ATTACHMENT 1

This listing denotes those pages to Appendix A, Technical Specifications which are revised as a result of re-evaluation of ECCS performance in conformance with the provisions of 10CFR 50.46 and of new ejected rod worth calculations.

## Single Failure Analysis

Containment Pressure

Figure 3.5.2-1A

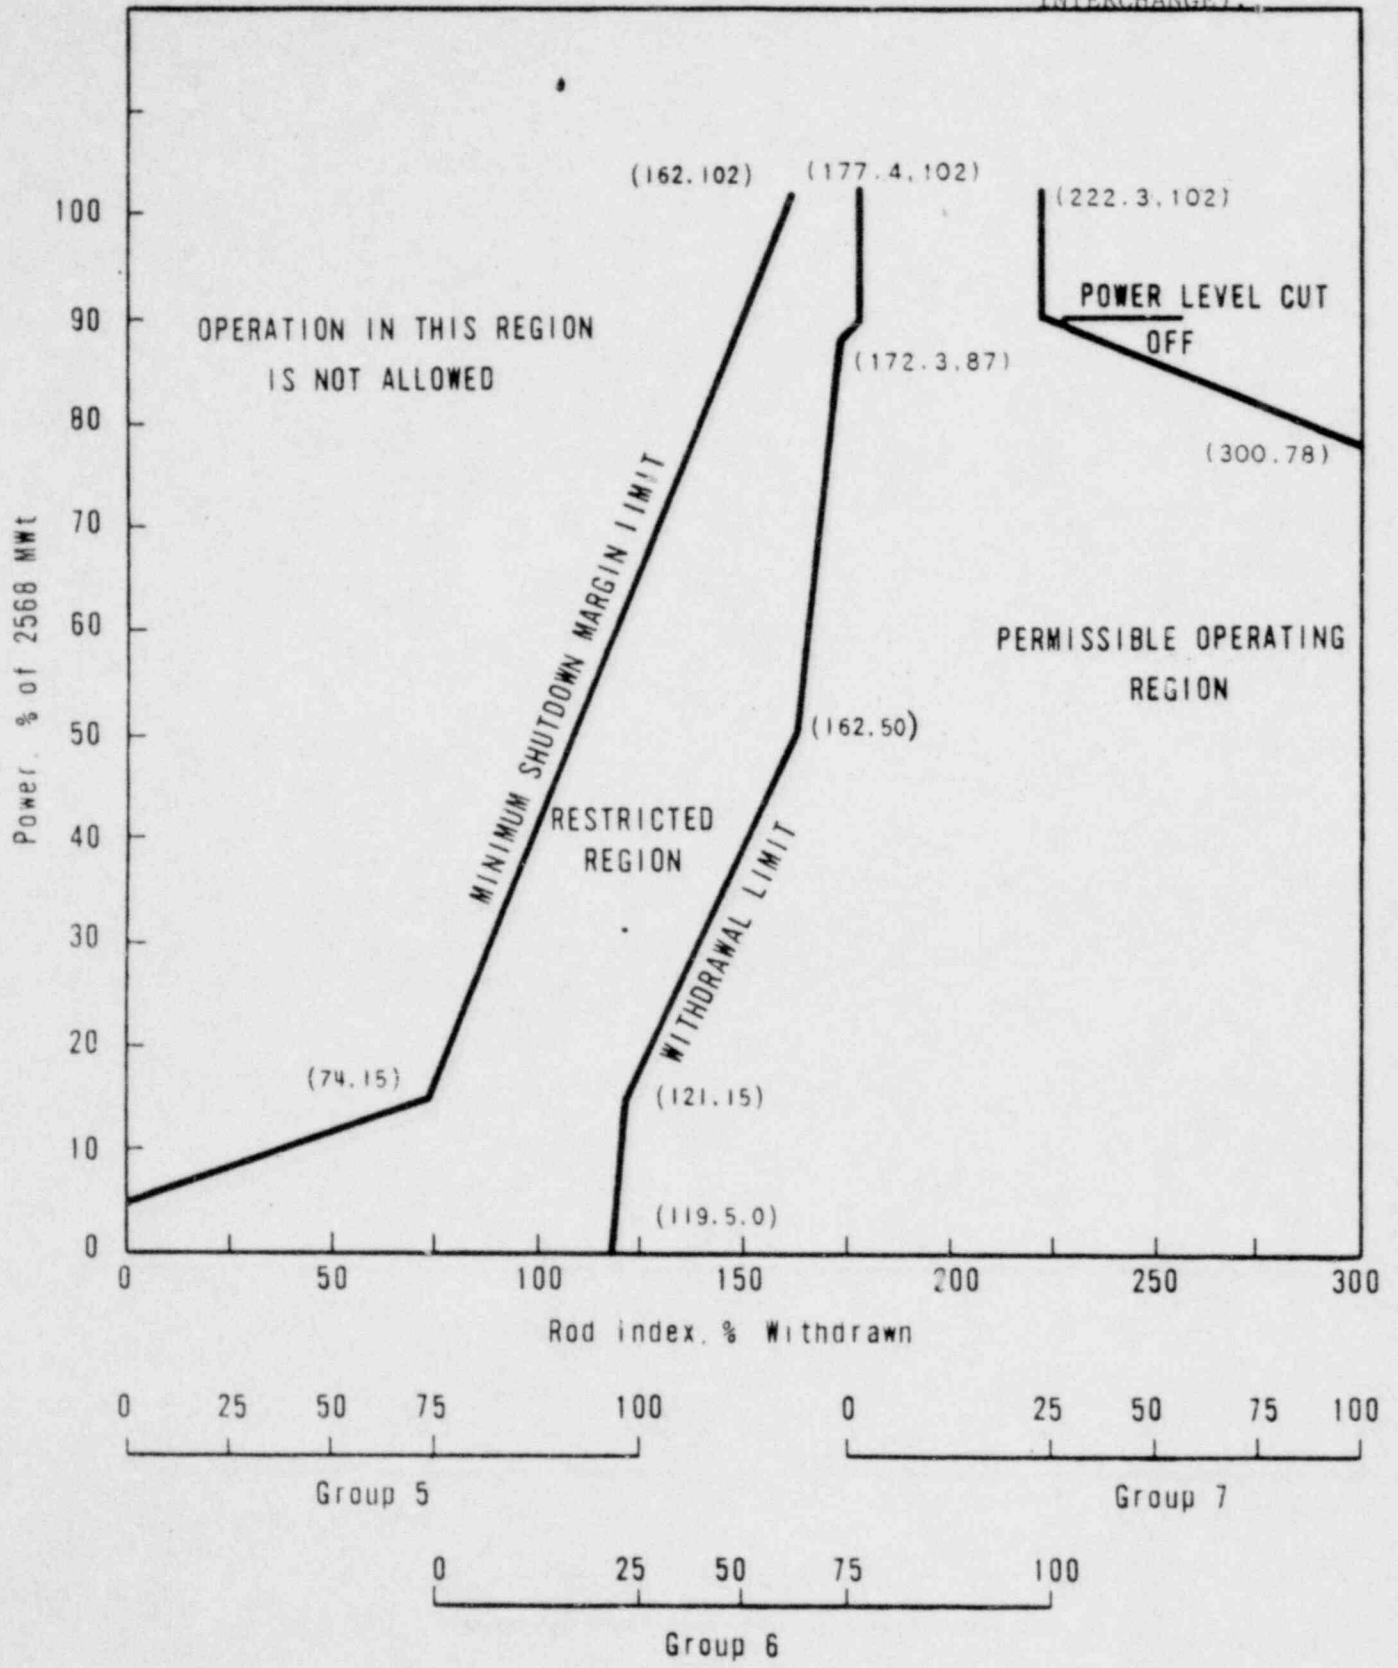
ROD POSITION LIMITS FOR 4 PUMP OPERATION APPLICABLE DURING THE PERIOD FROM 100 EFPD TO 250±10 EFPD (PRIOR TO CONTROL ROD INTERCHANGE).

Rod index is the percentage sum of the withdrawal of Groups 5, 6 and 7.

UNIT 1  
ROD POSITION LIMITS  
Figure 3.5.2-1B

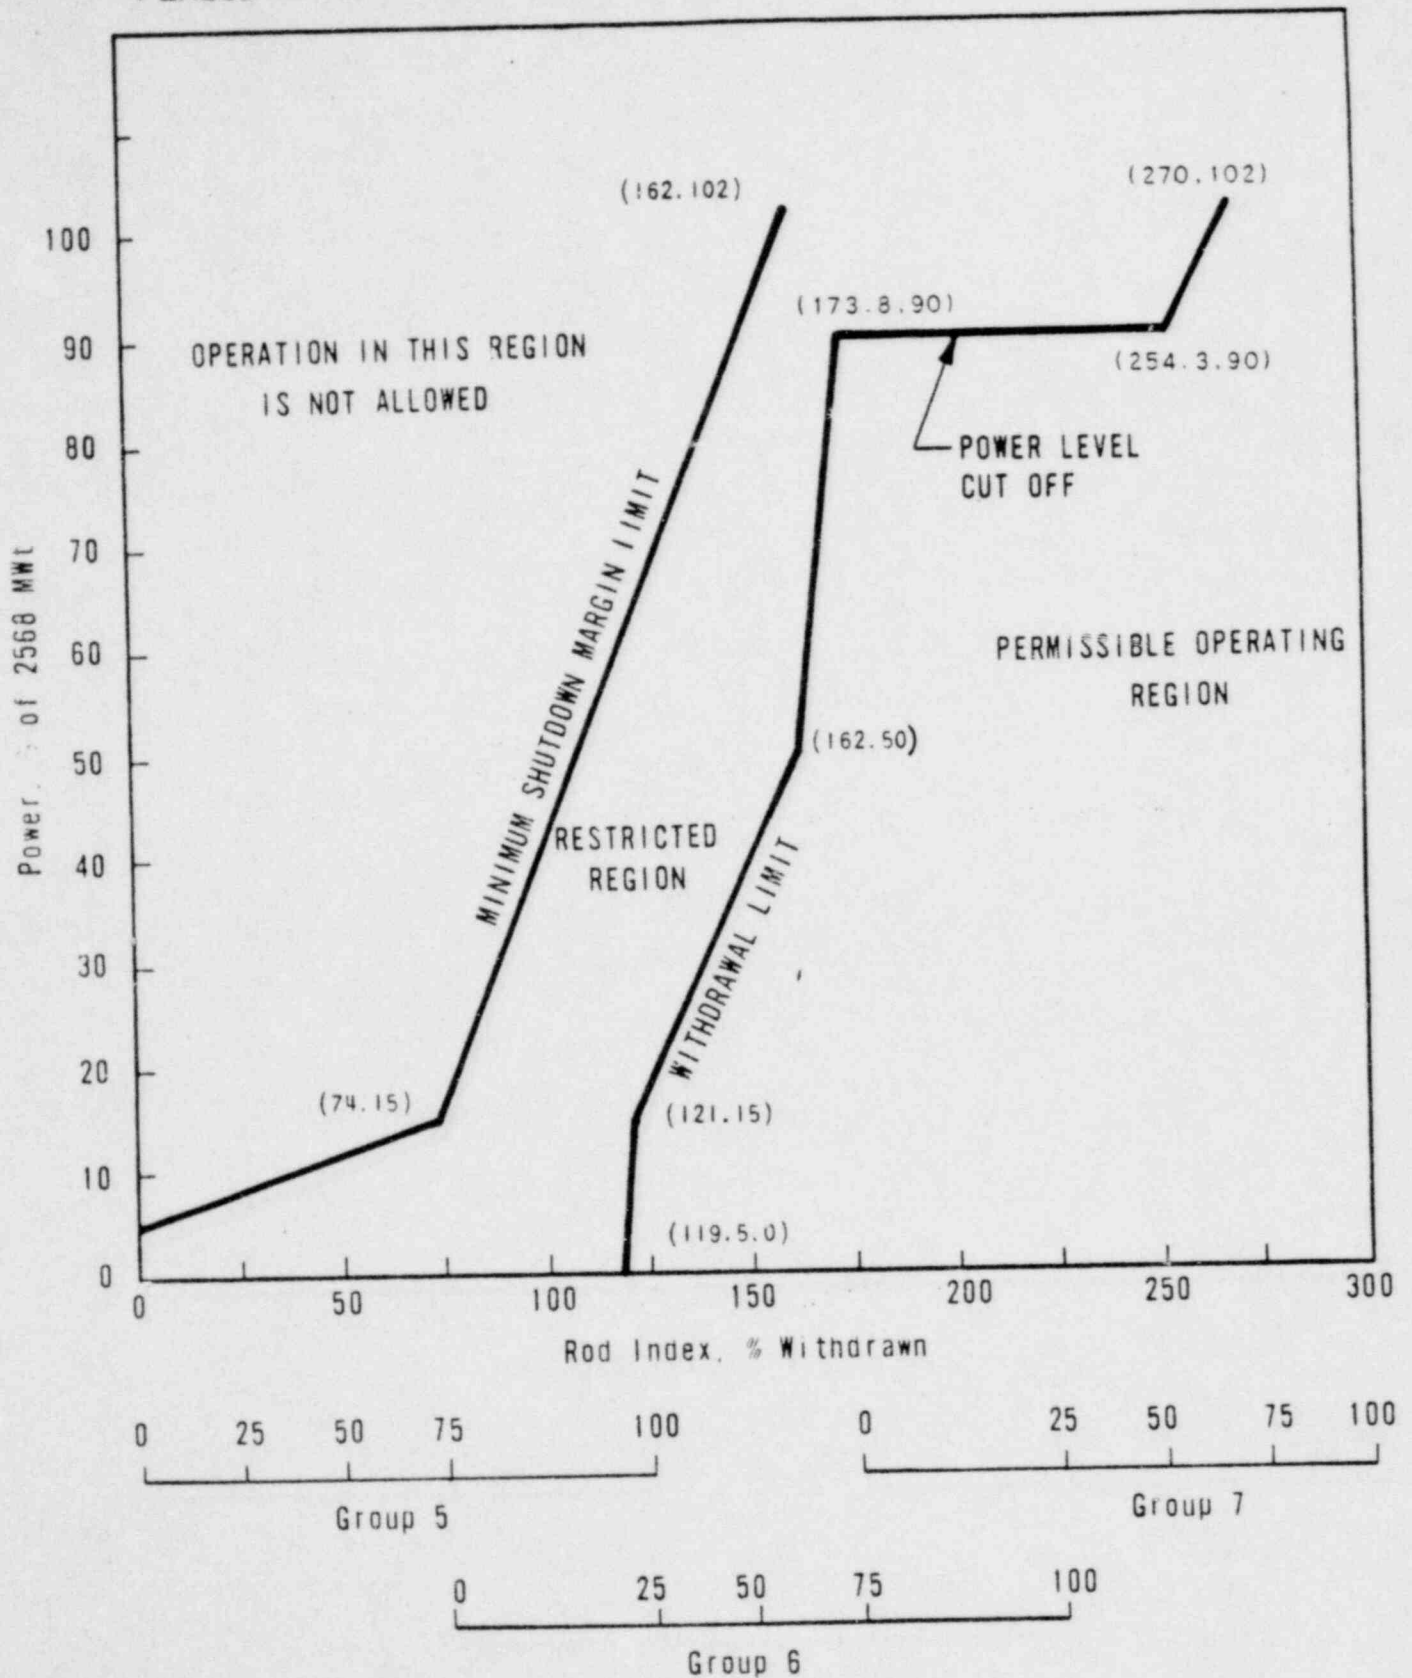
ROD POSITION LIMITS FOR 4 PUMP OPERATION APPLICABLE DURING THE PERIOD FROM 250±10 EFPD TO 435±10 EFPD (AFTER CONTROL ROD INTERCHANGE).

Rod index is the percentage sum of the withdrawal of Groups 5, 6 and 7.

UNIT 1  
ROD POSITION LIMITS  
Figure 3.5.2-1C

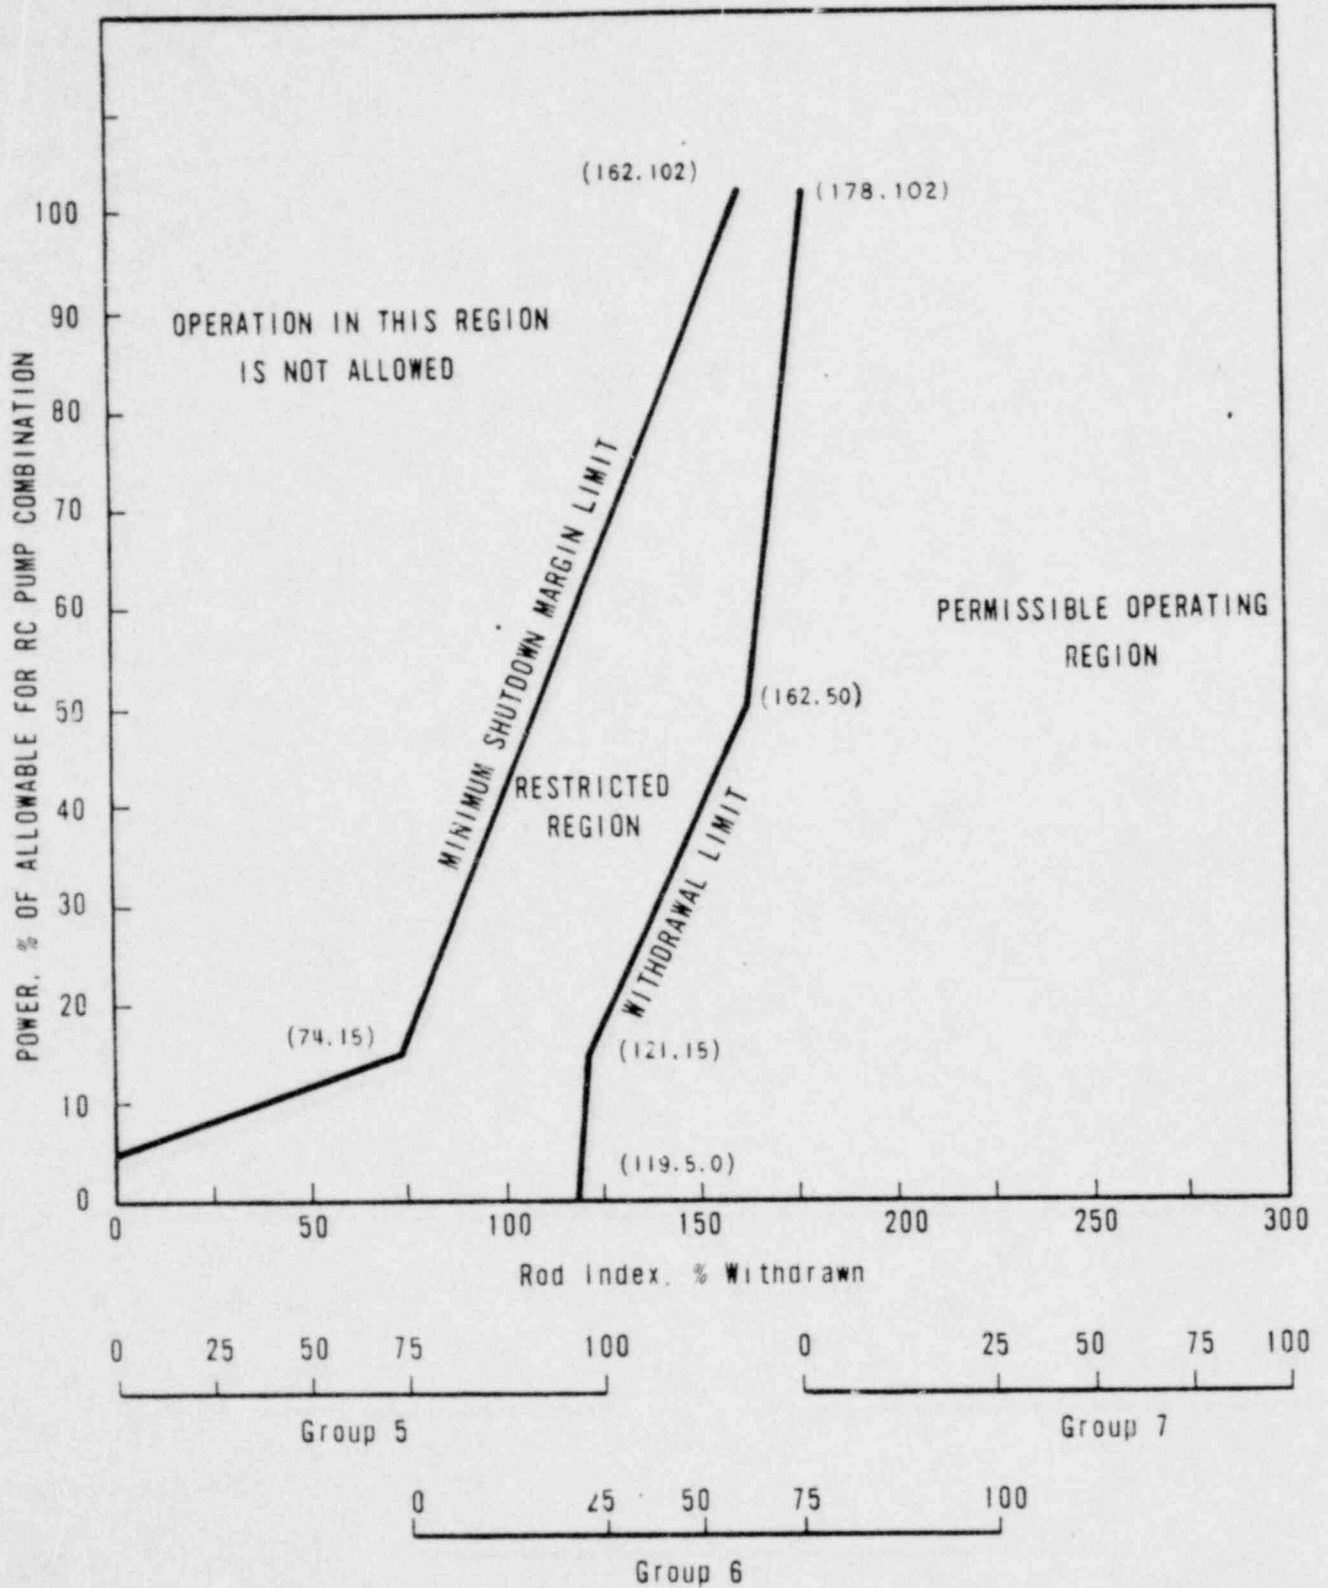
ROD POSITION LIMIT FOR 4 PUMP OPERATION APPLICABLE DURING THE PERIOD AFTER 435±10 EFPO.

Rod index is the percentage sum of the withdrawal of Groups 5, 6 and 7.

Figure 3.5.2-2

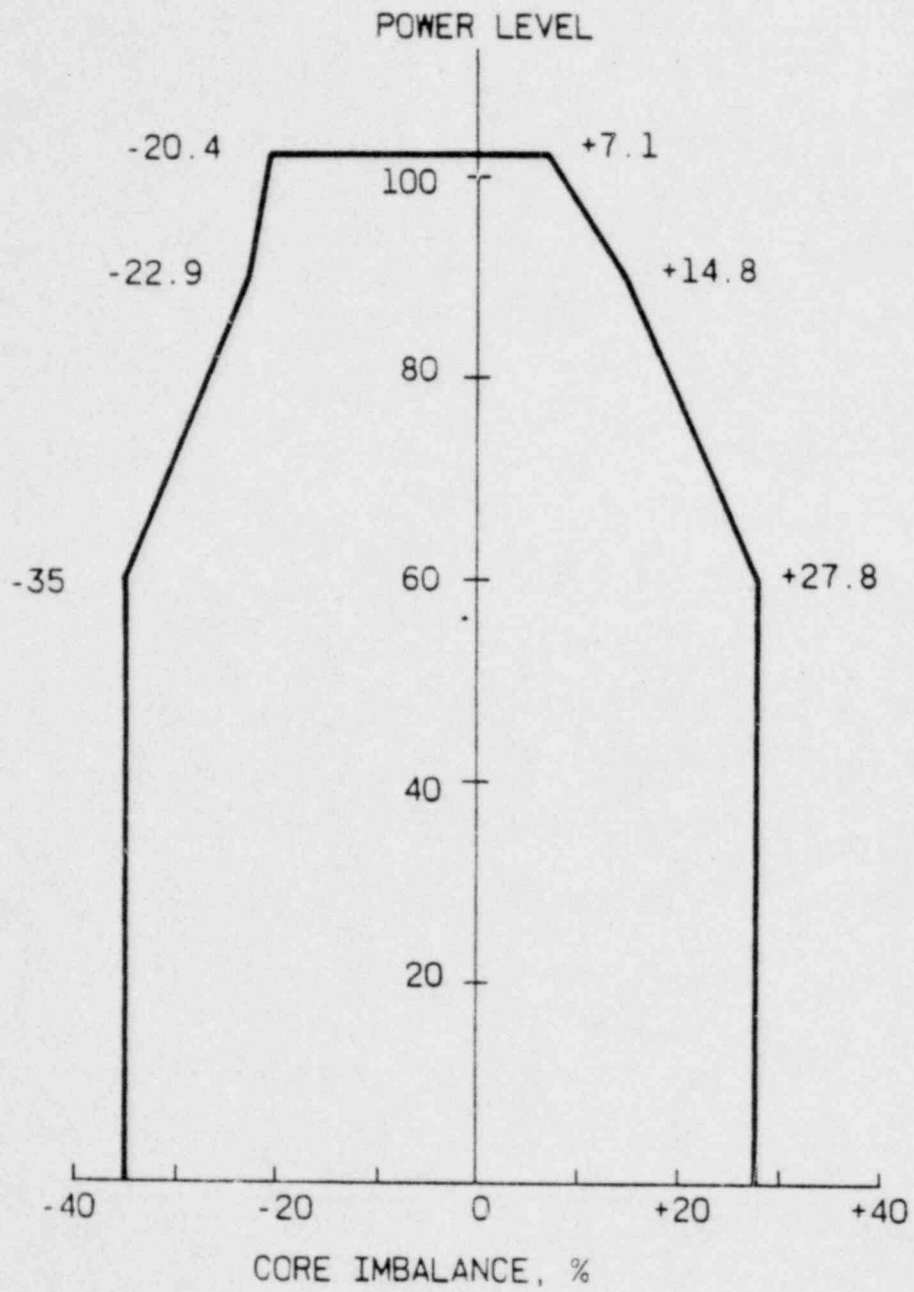
ROD POSITION LIMITS FOR 2 AND 3 PUMP OPERATION AFTER 250±10 EFPO

Rod index is the percentage sum of the withdrawal of Groups 5, 6 and 7
